COUNTY OF MIDDLESEX - INTERROGATORY #1

Filed: May 23, 2013
EB-2013-0040 and EB-2013-0041
Exhibit B
Tab 1
Schedule 3
Responses to County of
Middlesex Interrogatories
Appendix A

APPENDIX 'A'

Filed: May 23, 2013
EB-2013-0040 and EB-2013-0041
Exhibit B
Tab 1
Schedule 3
Responses to County of
Middlesex Interrogatories
Appendix B

APPENDIX 'B'

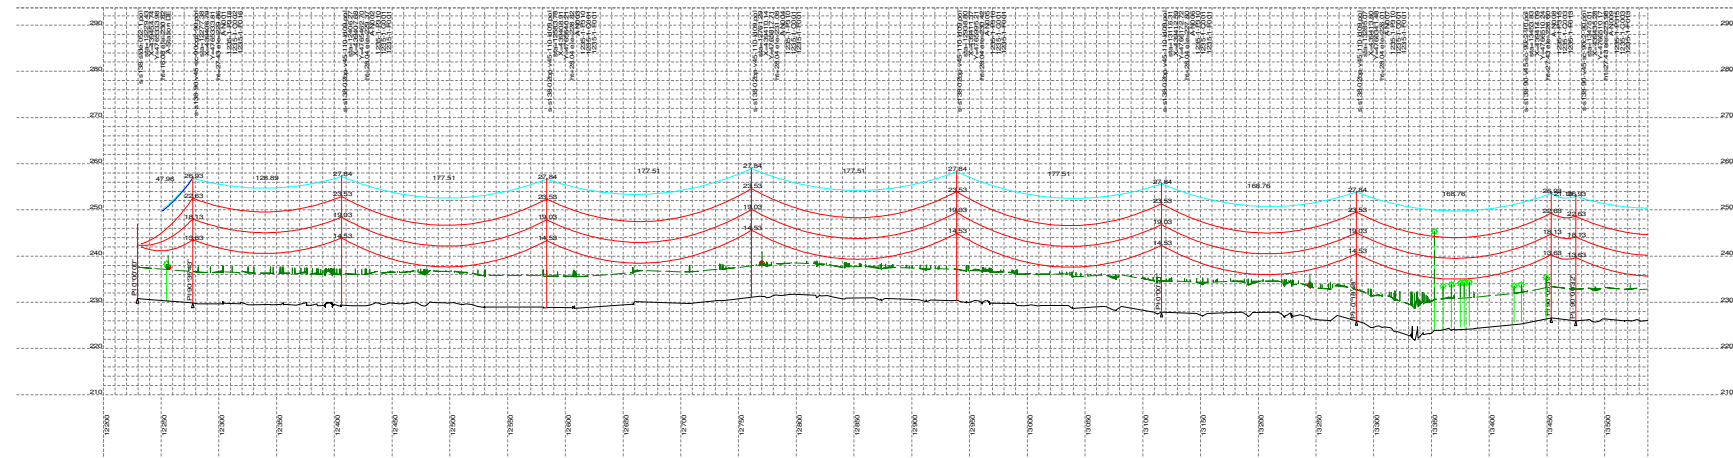
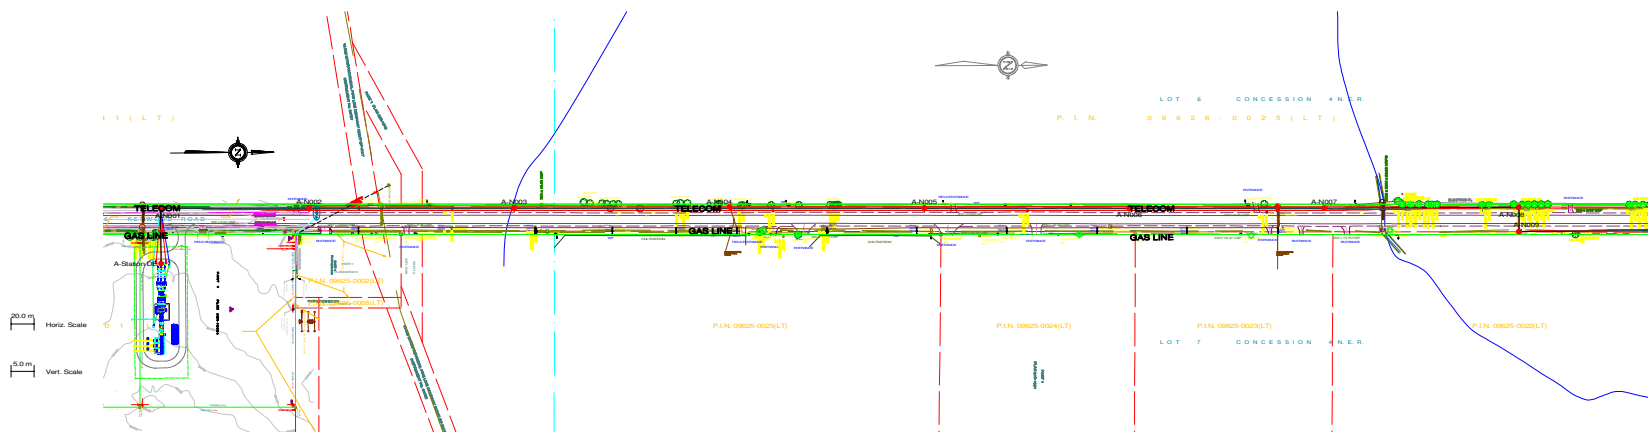
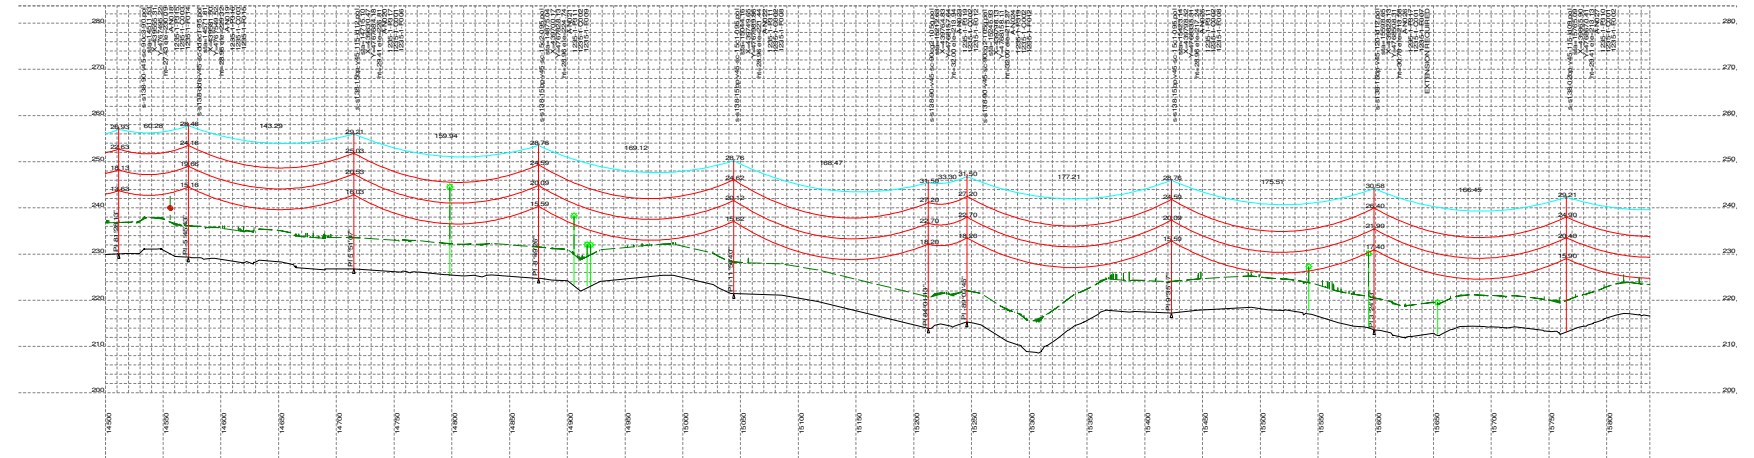
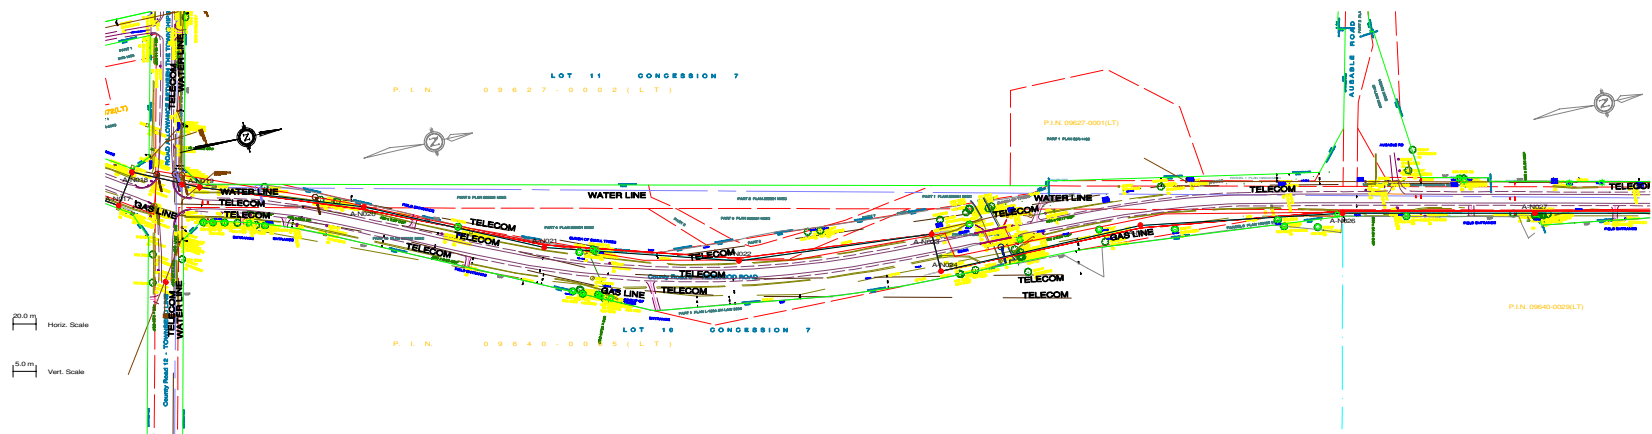
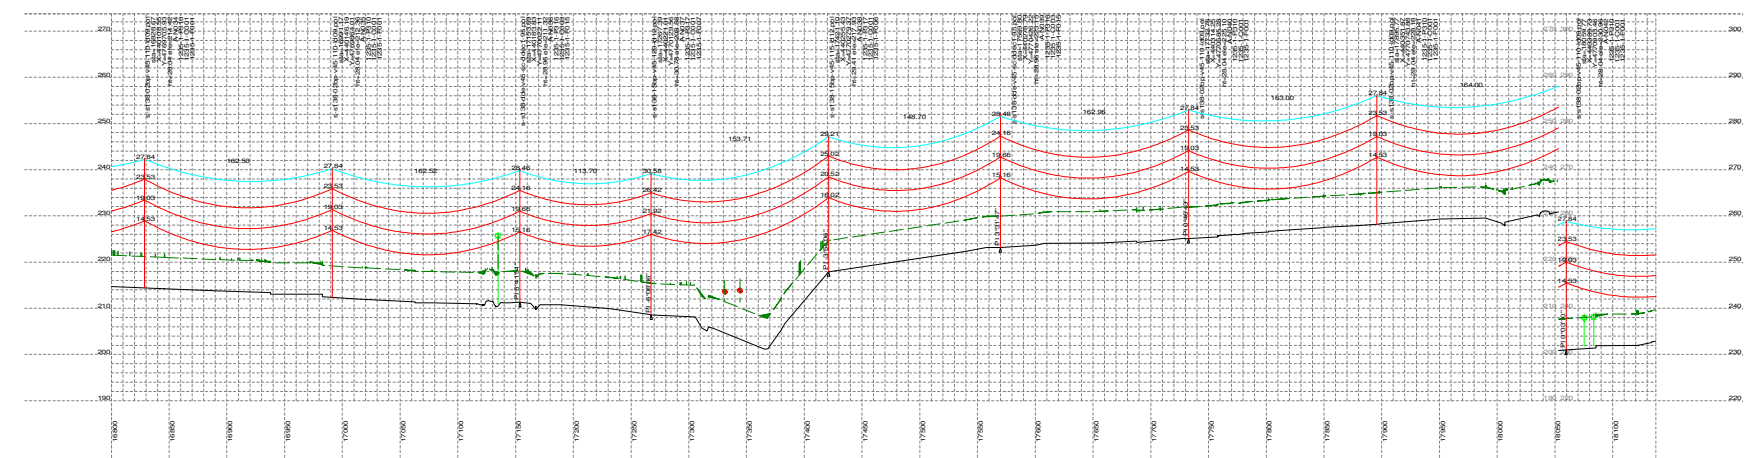
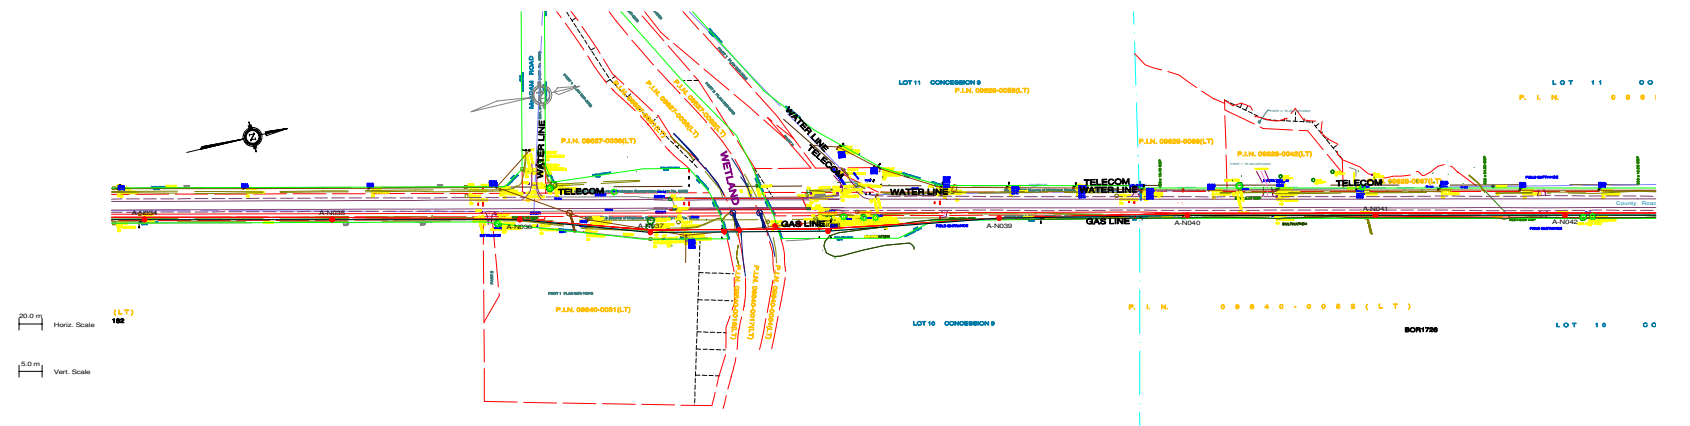
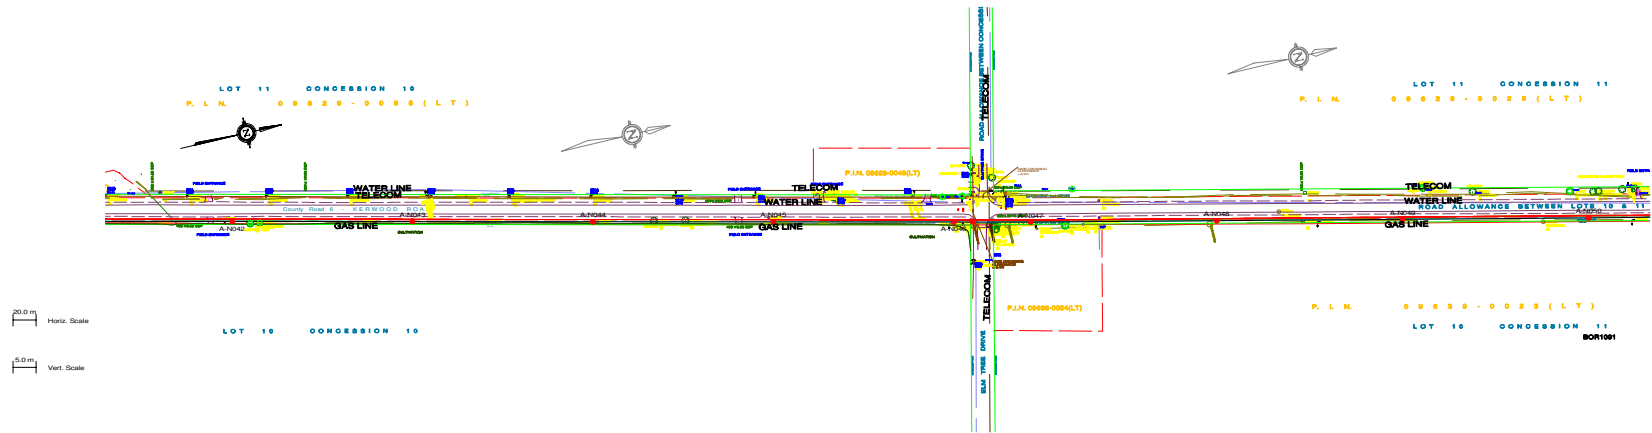
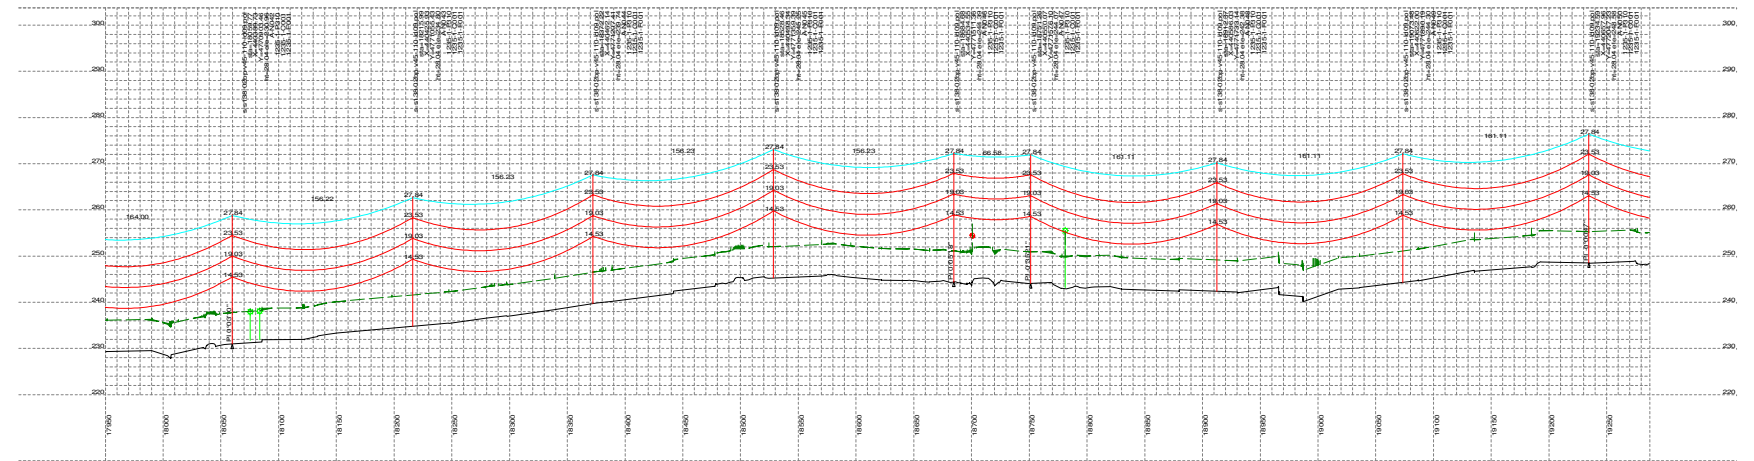
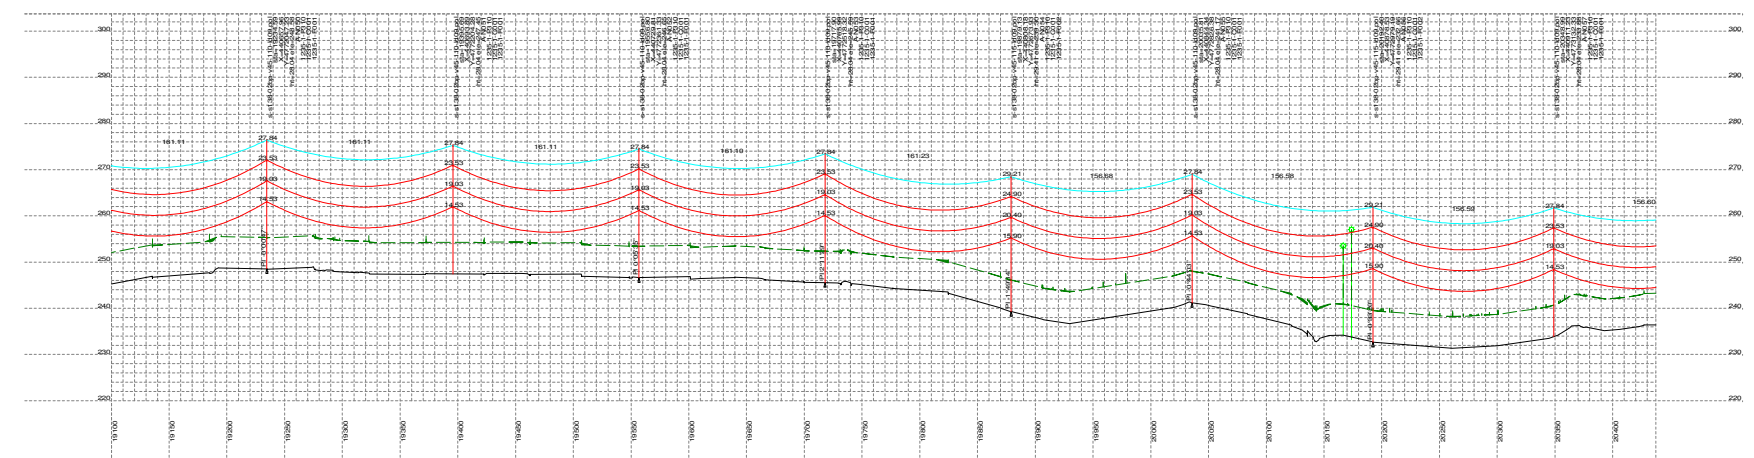
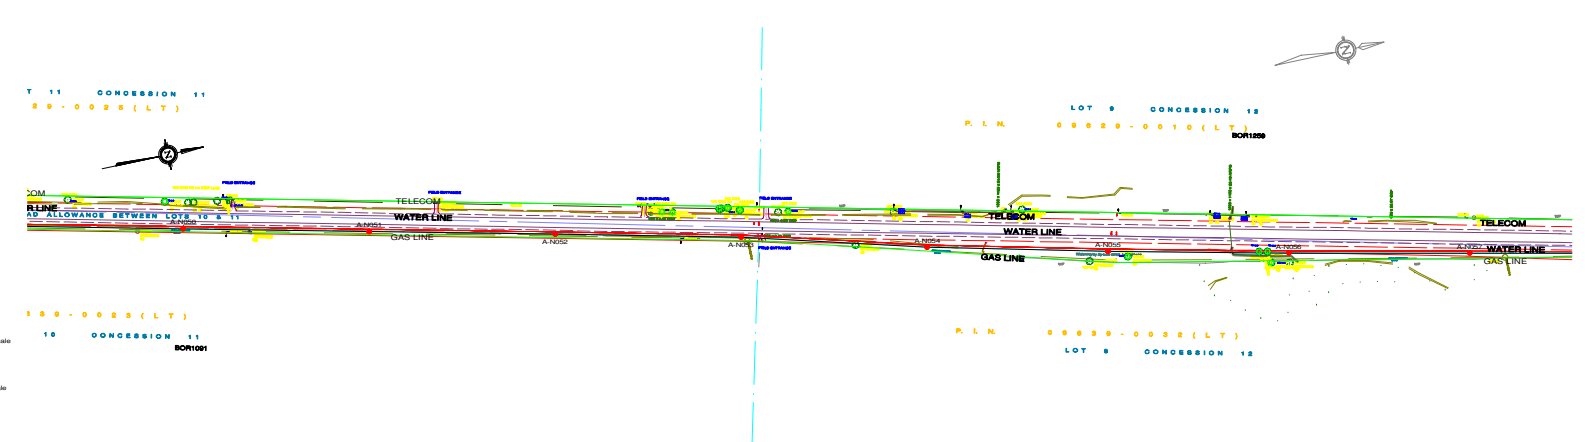
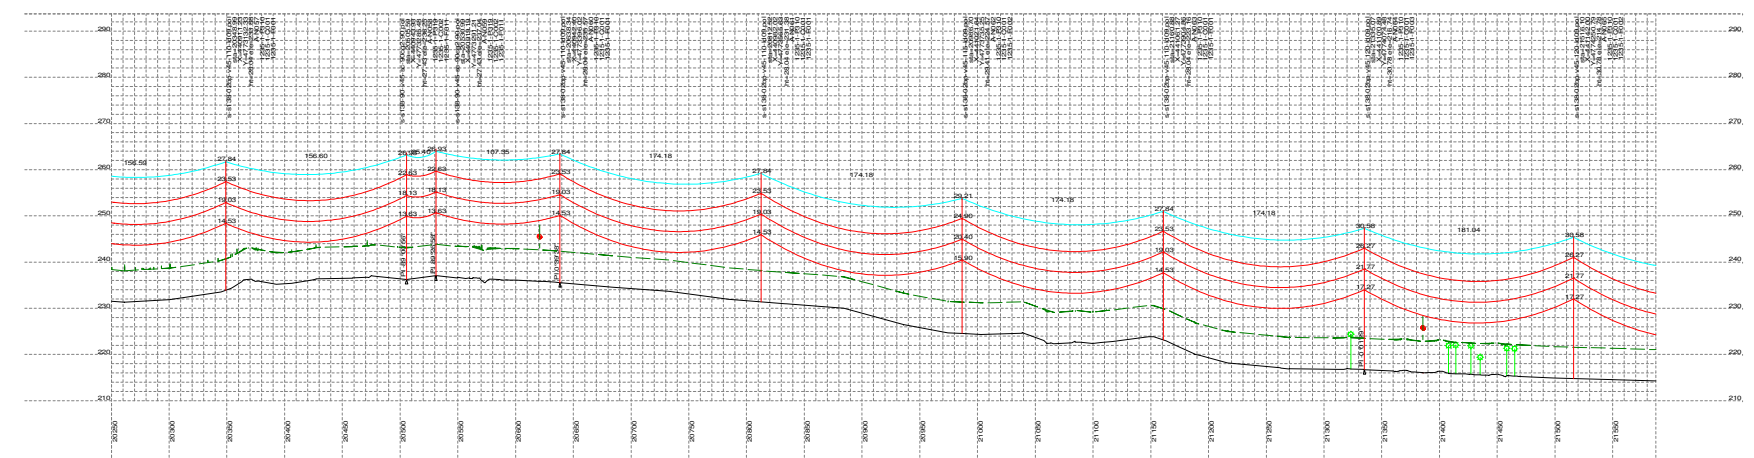
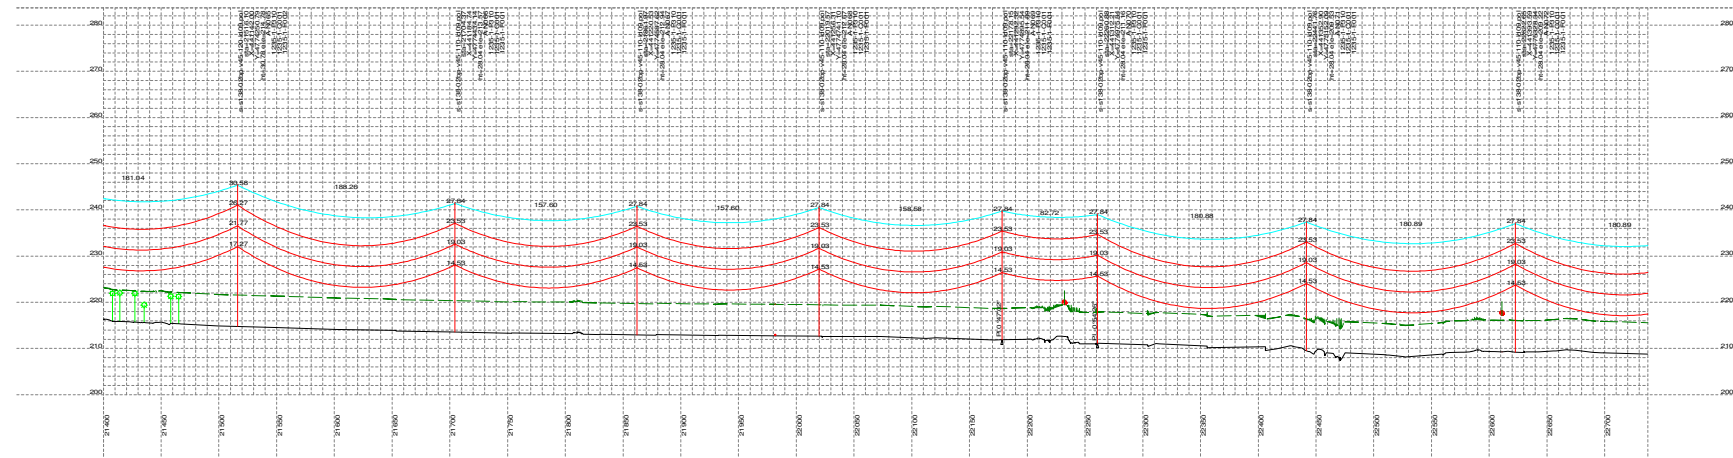
Please provide detailed engineering drawings showing the exact location of all poles and other appurtenances proposed to be located within County road allowances for transmission lines, including all material and construction specifications of poles, wires, guying, foundations, trenching, temporary conditions, and any other items related to this infrastructure.

Please see profile drawings in **Appendix 'A'** in respect of EB-2013-0040 and **Appendix 'B'** in respect of EB-2013-0041 depicting the current design, which is subject to final engineering. Earlier versions of these sets of drawings were provided to the County's Engineer on November 12, 2012. These drawings show the proposed pole, wire and anchor locations. Plans with respect to foundations, materials and construction specifications are not yet finalized. The physical design specifications for the proposed transmission line, including with respect to potential materials, are described in Exhibit D, Tab 1, Schedule 1. In addition, illustrations of potential pole structures and framing designs are provided in Figure 4 of Exhibit B, Tab 2, Schedule 5.
